Application No. 申請編號	(For Official Use Only) (請勿填寫此欄)		
Location/address 位置/地址	GOVERNMENT LAND AT TUNNEL APPROACH REST GARDEN, WAN CHAI 位於灣仔隧道入口處休憩花園的政府土地		
Site area 地盤面積	1,090 (SITE A: 540m <sup>2</sup> , SITE B: 550m <sup>2</sup> ) sq. m 平方米 <input checked="" type="checkbox"/> About 約 (includes Government land of 包括政府土地 1,090 sq. m 平方米 <input checked="" type="checkbox"/> About 約)		
Plan 圖則	DRAFT WAN CHAI NORTH OUTLINE ZONING PLAN NO. S/H25/5 灣仔北分區計劃大綱草圖編號S/H25/5		
Zoning 地帶	"OTHER SPECIFIED USES" ANNOTATED "AMENITY AREA" AND "ROAD" 其他指定用途 (美化市容地帶) 及道路		
Applied use/ development 申請用途/發展	PROPOSED PUBLIC UTILITY INSTALLATION (DRY WEATHER FLOW INTERCEPTOR) 擬議公共事業設施裝置(旱季截流閘)

**PWP Item No. 4444DS**  
**Construction of Dry Weather Flow Interceptor at Wan Chai East**  
**Application for Planning Permission under Section 16**  
**of Town Planning Ordinance for Construction of Dry Weather Flow Interceptor**  
**at Wan Chai East**

**Application for Planning Permission under Section 16 of the Town Planning  
Ordinance for Construction of Dry Weather Flow Interceptor at Wan Chai East  
Application No. A/H25/22**

**Planning Application No. A/H25/22**  
**Application for Permission under S

ANNEX C: COMPENSATORY PLANTING  
AND TREE TRANSPLANTING PLAN

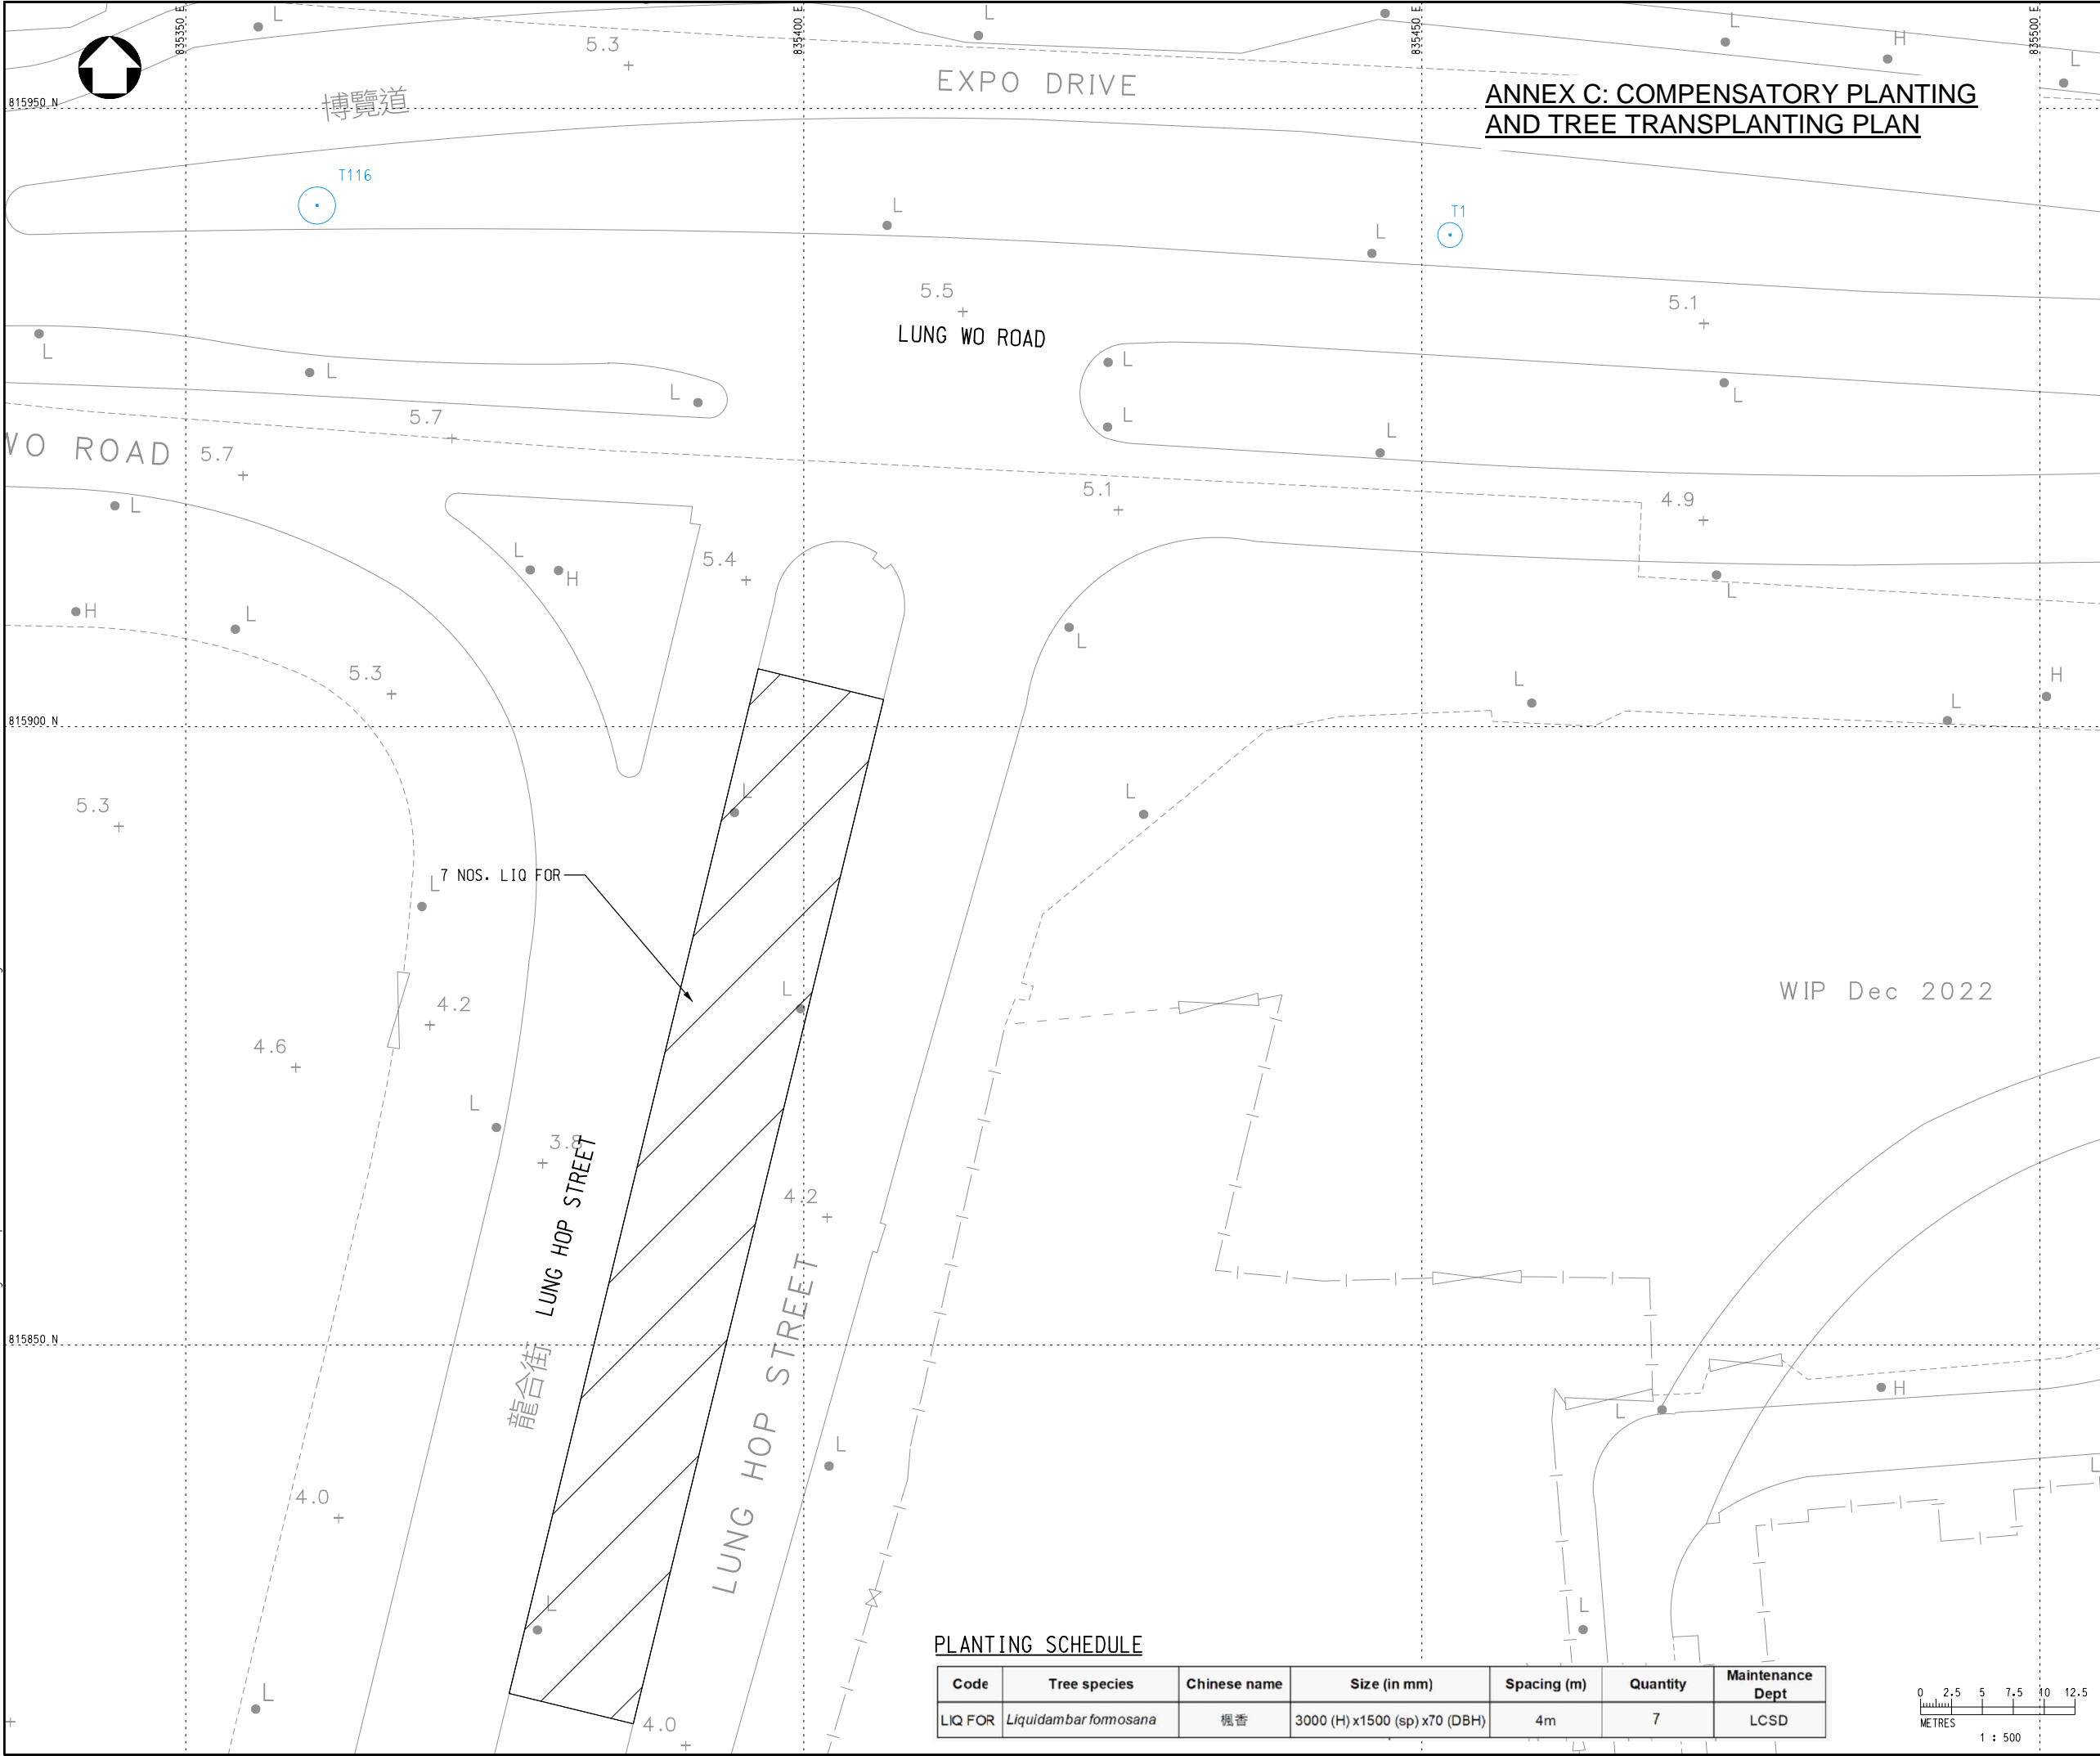
3	According to Tree Assessment Schedule of Appendix H - Tree Survey Report, T116 at Site B is proposed to be transplanted but it's ranked "Low" in suitability for transplanting. The applicant is advised to reassess the recommendation for T116 whether suitable for transplant/remove with fully justifications	<p>T116 is graded as average in terms of Form, Health and Structural Condition and have a medium rating in Amenity value. Considering this tree is a palm tree by which only small rootball size will be required for transplantation, therefore, T116 is suitable for transplanting.</p> <p>The suitability of transplanting T116 has been revised as 'Medium'. The revised Tree Assessment Schedule is provided in <b>Annex C</b>.</p>
4	The location of compensatory planting for T116 is not tally with our counter proposal to WSP, the project consultant via email reply on 4 September 2023.	Noted, the location of compensatory planting for T116 has been revised. The revised Compensatory Planting and Tree Transplanting Plan is provided in <b>Annex C</b> .

<b><u>No.</u></b>	<b><u>Comments Received</u></b>	<b><u>Responses</u></b>
	Management Section of Development Bureau on tree preservation.	
2	T116 at Site B is proposed to be transplanted. However, it is ranked "Low" in Suitability for Transplanting in the Tree Assessment Schedule. The applicant should consider and clarify if T116 is suitable for transplanting.	<p>T116 is graded as average in terms of Form, Health and Structural Condition and have a medium rating in Amenity value. Considering this tree is a palm tree by which only small rootball size will be required for transplantation, therefore, T116 is suitable for transplanting.</p> <p>The suitability of transplanting T116 has been revised as 'Medium'. The revised Tree Assessment Schedule is provided in <b>Annex C</b>.</p>
<b>5</b>	<b>Hong Kong &amp; Islands, Drainage Services Department, 27 September 2023</b>	
	I refer to your memo under reference regarding the captioned S16 planning application.

**ANNEX C – REVISED COMPENSATORY PLANTING AND TREE TRANSPLANTING  
PLAN (CE39/S16/TS/002)**

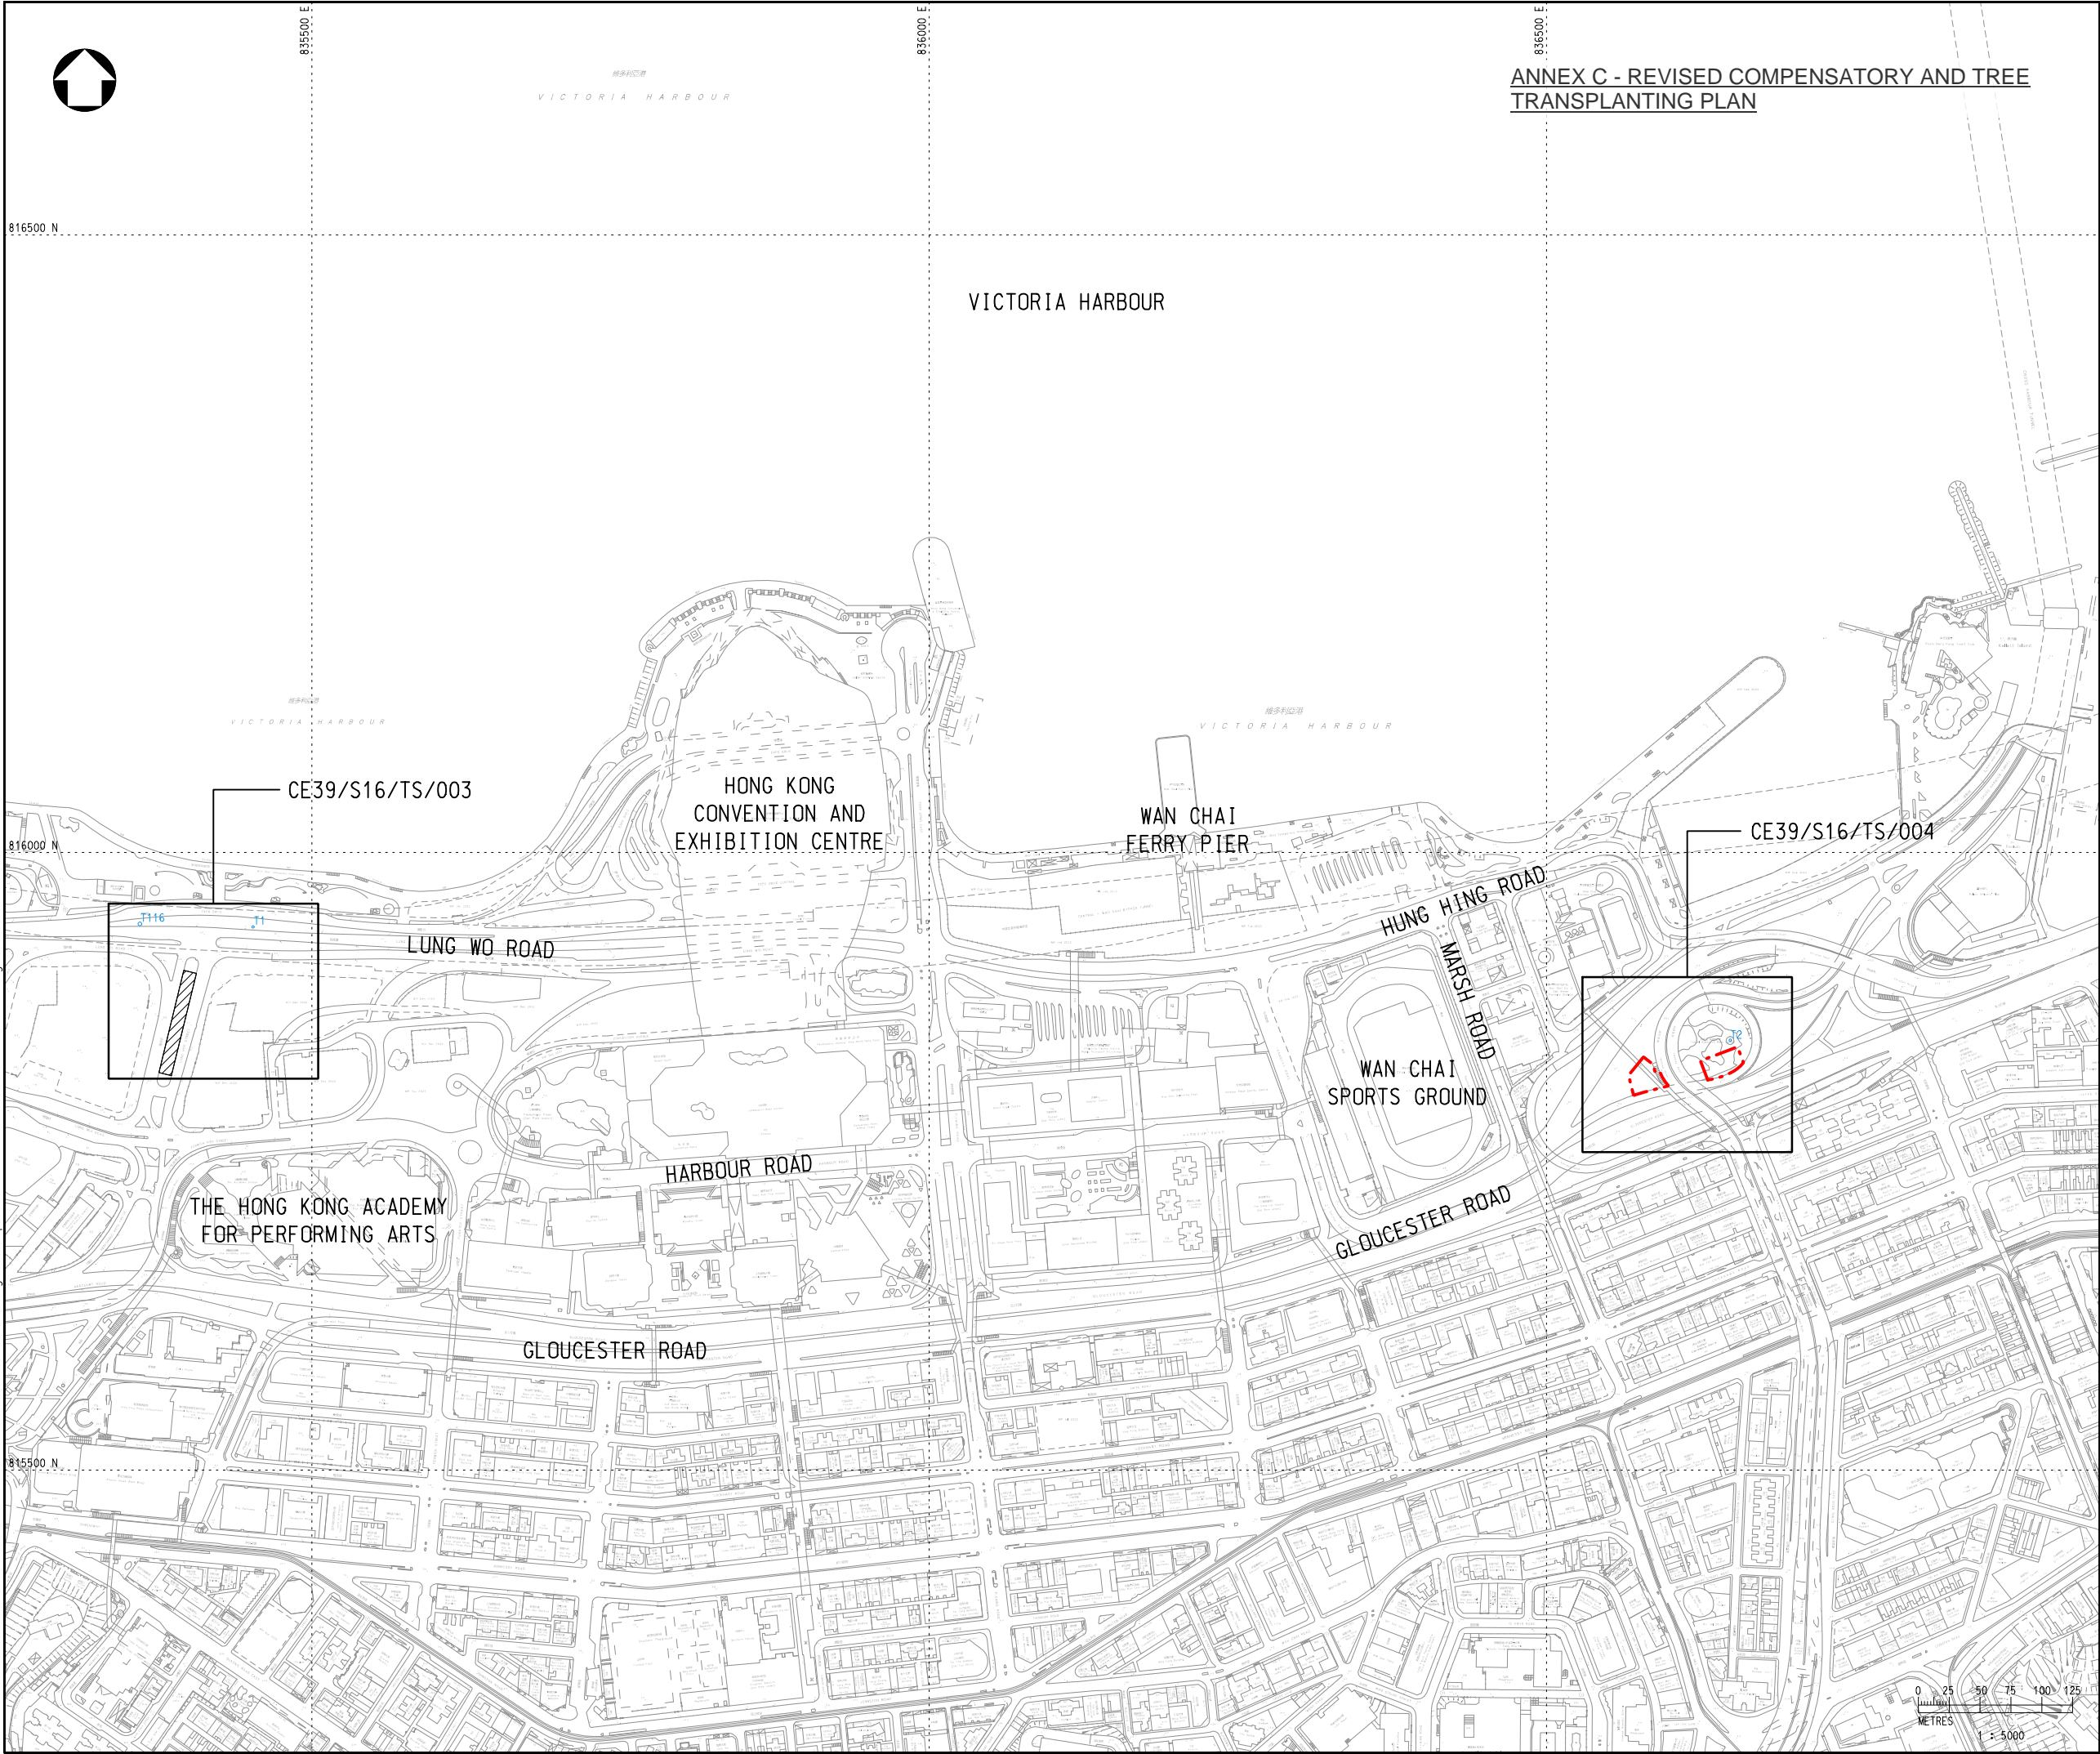
<b>3</b>	<b>Planning Department, Email dated 9 October 2023</b>	
1	<b>Design of FID:</b> with reference to the Landscape Section A plan, it is noted that solar panel is proposed on the roof of the canopy of the FID. Please advise the purpose/function of such solar panel	The solar PV panel is proposed to support the lighting for the canopy of FID.
2	<b>Compensation of Trees:</b> according to Tree Survey Report and Tree Preservation & Removal Proposal, a compensatory ratio of 1:1 in terms of quantity would be achieved for the loss of 7 to-be-felled trees (i.e. 7 compensatory trees will be planted). Please clarify, in terms of <b>quality</b> , whether the compensatory trees will be of the same as/similar to those existing trees to be	The compensatory planting proposal has taken into consideration the principle as outlined in TC(W) 04/2020 Tree Preservation, in which the planting design strikes to balance the quantity and quality of tree planting. While the quantity aspect has been met, the proposed tree species and size are based on the available space of planting locations in the vicinity of

<b>No.</b>	<b><u>Comments Received</u></b>	<b><u>Responses</u></b>
	removed	Site. <i>Liquidambar formosana</i> is a native species, it is also on the recommended tree list for Sheung Wan, Wan Chai & Causeway Bay District GMP. Furthermore, some <i>Liquidambar. formosana</i> are already planted on the proposed locations. The proposed 7 nos. <i>Liquidambar formosana</i> would provide a harmonized landscape design and enhance the overall amenity value of the area.
3	As the application site is in close vicinity to the major carriageway of Gloucester Road and given that the FID at Site A would have a height of about 2.6m, please advise any sightline analysis to demonstrate that no impact would be induced to drivers	Sightline analysis was conducted for the proposed FID, it is confirmed that there is no impact induced to the drivers ( <b>Annex A</b> refers).
<b>4</b>	<b>Transport Department, Email dated 16 October 2023</b>
